REF #: ICI14-016

SUBJECT: Notice for Ricon Chair Lift Platform Recall on TBB Buses

Subject: Ricon Chair Lift Platforms

RE: Safety Defect Recall Notification (Recall Notification 14E-041)

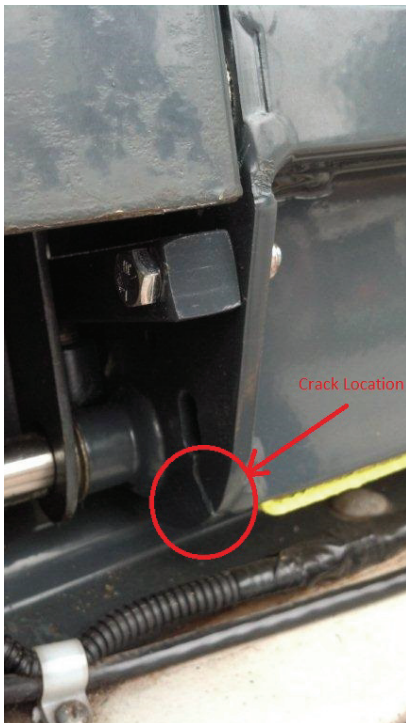
Under certain conditions the side plate of the larger platforms included on the subject S-Series model wheelchair lifts can exhibit cracking while in the stowed position which, if left unchecked can propagate to the point where separation of the rear portion of the side plate occurs rendering the lift inoperable and possibly unsafe to use.

The cracking as illustrated has been observed on less than 5% of the subject population and appears to be caused by a combination of factors including but not necessarily limited to, incomplete stowing of the lift and/or maladjustment or otherwise malfunctioning of the stow lock devise combined with a violent side- to- side movement that might be associated with traversing curbs, speed bumps and other variable road conditions, especially at higher speeds.

If cracks are found, the platform must be replaced as soon as possible. Use the following part numbers for the associated model numbers.

For Models S1205-G, S1205VG	Use PN 33851
For Models S2005-S, S5005-S, S2005-T, S5005-T	Use PN V2-PF-389
For Models S2005-F, S5005-F, S2005-G, S2005-C, S2005VF, S2005-J	Use PN 32466
For Models S2005-L, S5005-L	Use PN 38330
For Models S2010-S, S2010-T, S5010-S, S5010-T	Use PN 16622
For Models S2010VF, S2010-C, S2010-F, S5010-F	Use PN 32469
For Models S5505-S	Use PN 34846
For Models S5505VF, S5505-C, S5505-F	Use PN 33485
For Models S5510VF, S5510-F, S5510C, S5510-J	Use PN 34249

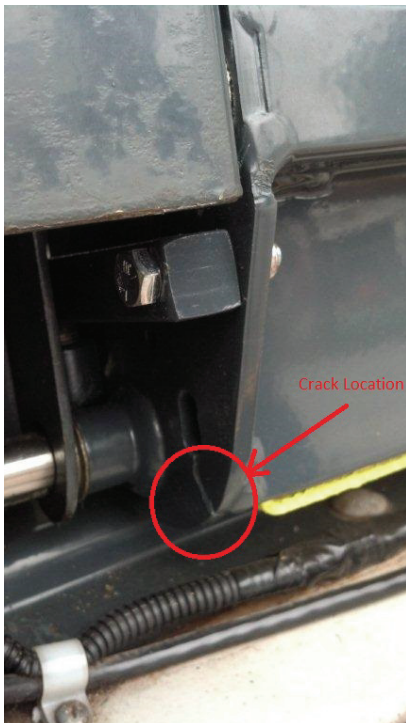
Under certain conditions the side plate of the larger platforms included on the subject S-Series model wheelchair lifts can exhibit cracking while in the stowed position which, if left unchecked can propagate to the point where separation of the rear portion of the side plate occurs rendering the lift inoperable and possibly unsafe to use.

The cracking as illustrated has been observed on less than 5% of the subject population and appears to be caused by a combination of factors including but not necessarily limited to, incomplete stowing of the lift and/or maladjustment or otherwise malfunctioning of the stow lock devise combined with a violent side- to- side movement that might be associated with traversing curbs, speed bumps and other variable road conditions, especially at higher speeds.

If cracks are found, the platform must be replaced as soon as possible. Use the following part numbers for the associated model numbers.

For Models S1205-G, S1205VG	Use PN 33851
For Models S2005-S, S5005-S, S2005-T, S5005-T	Use PN V2-PF-389
For Models S2005-F, S5005-F, S2005-G, S2005-C, S2005VF, S2005-J	Use PN 32466
For Models S2005-L, S5005-L	Use PN 38330
For Models S2010-S, S2010-T, S5010-S, S5010-T	Use PN 16622
For Models S2010VF, S2010-C, S2010-F, S5010-F	Use PN 32469
For Models S5505-S	Use PN 34846
For Models S5505VF, S5505-C, S5505-F	Use PN 33485
For Models S5510VF, S5510-F, S5510C, S5510-J	Use PN 34249
